Model: Stinger-C1 Fax Option		Date: 15-Jan-00	No.: MA891001
Modified Article: Modular Cord Change		Prepared by: K. Miura	
From: Technical Services Dept., GTS Division			
Reason for Modification:	☐ Parts catalog correction ☐ To facilitate assembly ☒ Part standardization	☐ Vendor change ☐ To improve reliability ☐ Other	☐ To meet standards ()

Model: Stinger-C1 Fax Option	Date: 15-Jan-00	No.: MA891002a
------------------------------	-----------------	----------------

Model: Stinger-C1 Fax Option		Date: 15-Feb-00	No.: MA891003
Modified Article: Quick Dial Flap		Prepared by: K. Miura	
From: Technical Services Dept., GTS Division			
Reason for Modification:	☐ Parts catalog correction ☐ To facilitate assembly ☐ Part standardization	☐ Vendor change ☒ To improve reliability ☐ Other	☐ To meet standards ()

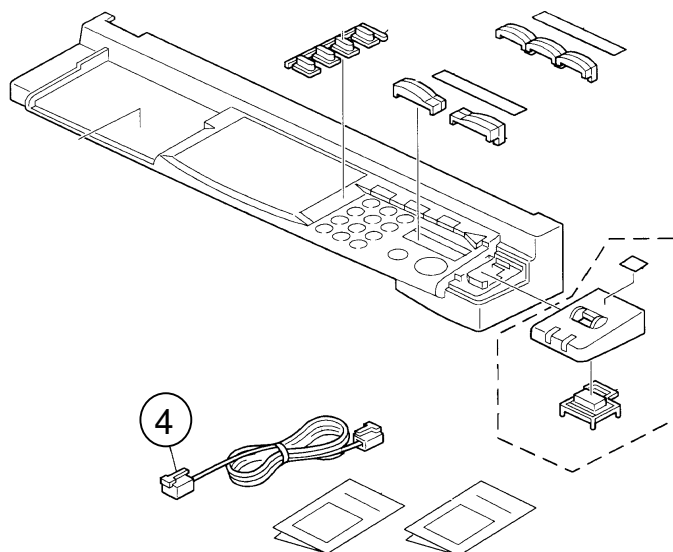
To meet the new standard, the modular cord has been changed.

Old part number	New part number	Description	Q'ty	Int	Page	Index	Note
H0815700	H5235350	Telephone Cable	1	X/O	5	4

Page 3

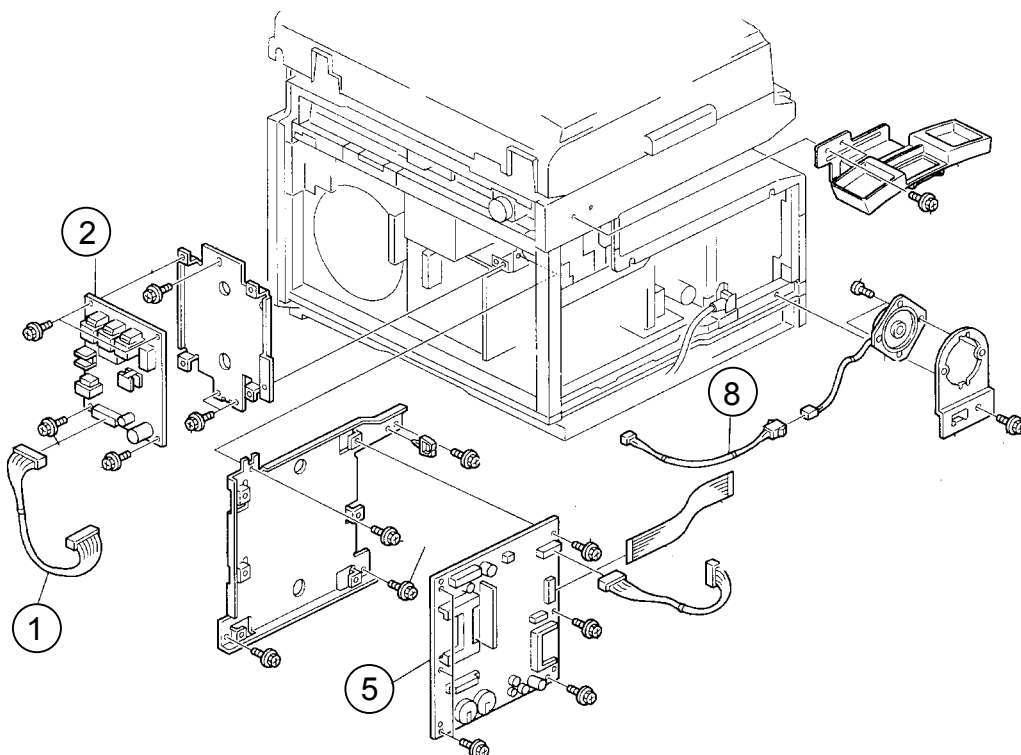
Old part number	New part number	Description	Index
A2915174		PCB – FCU (ASIA)	5
	A2915166	PCB – FCU (RIC-ASIA/TWN/CHN)	5

Part number	Old description	New description	Index
A2915276	Harness – FCU-NCU (EU/ASIA)	Harness – FCU-NCU (Except for NA)	1
54486142	PCB – NCU (EU/ASIA)	PCB – NCU (Except for NA)	2
A2915164	PCB – FCU (EU)	PCB – FCU (EU/OEM-ASIA)	5
A2915273	DC Harness – FCU-MS (EU/ASIA)	DC Harness – FCU-MS (Except for NA)	8

Page 5

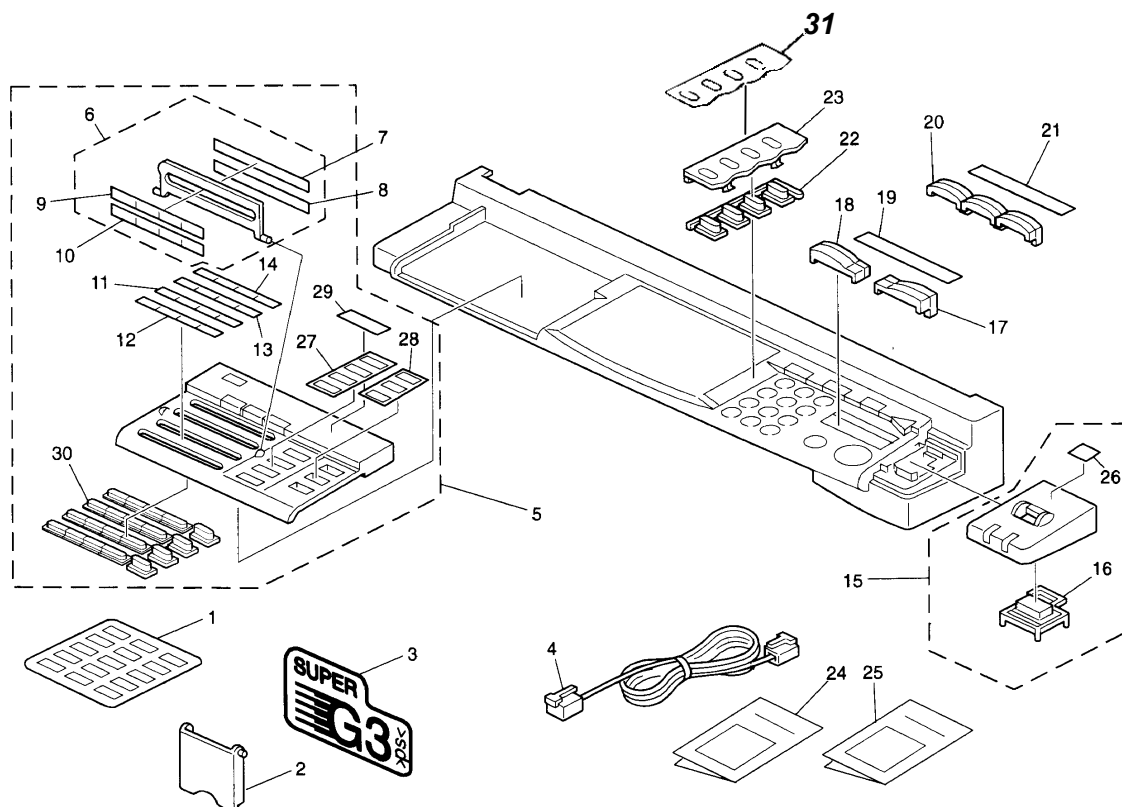
Part Number	Description	Old Index	New Index
A8911462	Sheet – Cover FAX NA (NA/ASIA)	27	29
A8911464	Sheet Cover Function NA (NA/ASIA)	29	27

Old part number	New part number	Description	Index
A8911473		Right Cover (EU)	23
	A8911474	Right Cover (EU/TWN/CHN)	23

Part number	Old description	New description	Index
A8918467	Fax Operation Panel A'ssy (EU)	Fax Operation Panel A'ssy (EU/TWN/CHN)	*
A8911475	Decal Operation – FAX Option (NA/ASIA only)	Decal Operation – FAX Option (Except for EU)	1
A8918467	Packing FC-KEY2 EU A'SSY (EU)	Packing FC-KEY2 EU A'SSY (EU/TWN/CHN)	5
A8910052	Power Switch A'ssy – A4 (EU)	Power Switch A'ssy – A4 (EU/TWN/CHN)	15
A8911473	Sheet – Power Source Cover A4 (EU)	Sheet – Power Source Cover A4 (EU/TWN/CHN)	26
A2501485	Sheet – Cover Zoom EU (EU)	Sheet – Cover Zoom EU (EU/TWN/CHN)	28

Part number	Description	Index
A8911518	Decal Operation (TWN)	1
A8911508	Decal Operation (CHN)	1
A8911516	Application Decal 2 (TWN)	19
A8911506	Application Decal 2 (CHN)	19
A8911517	Application Decal 3 (TWN)	21
A8911507	Application Decal 3 (CHN)	21
A8918609	Operating Instructions – Taiwanese	24
A8918606	Operating Instructions – Chainese	24
A8918659	CS Manual – Taiwanese	25
A8918656	CS Manual – Chinese	25
A8911502	Sheet – Cover Power Sorce (CHN)	26
A8911514	Sheet – Cover Function (TWN)	27
A8911504	Sheet – Cover Function (CHN)	27
A8911501	Sheet – Cover Zoom (CHN)	28
A8911513	Sheet – Cover FAX (TWN)	29
A8911503	Sheet – Cover FAX (CHN)	29
A8911515	Sheet – Right Cover (TWN)	31
A8911505	Sheet – Right Cover (CHN)	31
H5115007	Stamp	32

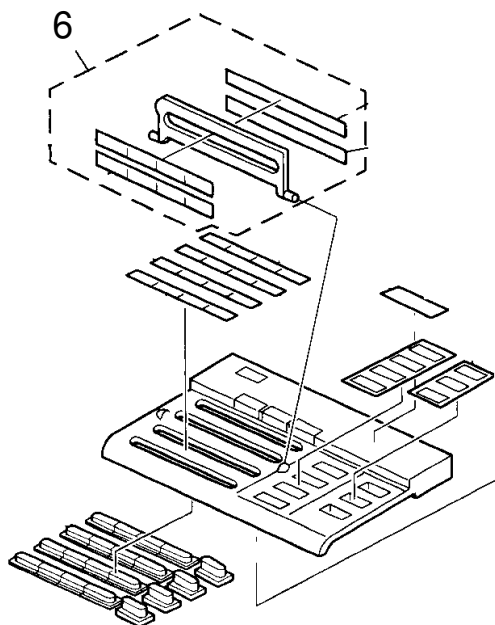
The decals that some customers use for the Quick Dial flap are sometimes thick enough to prevent the flap from pushing down on the detector. As a result, faxes are sent to the wrong destination. To prevent this, the flap itself has been made heavier.

Old part number	New part number	Description	Q'ty	Int	Page	Index	Note
A2509000	A2509001	Plate Onetouch Dial	1	X/O	5	6
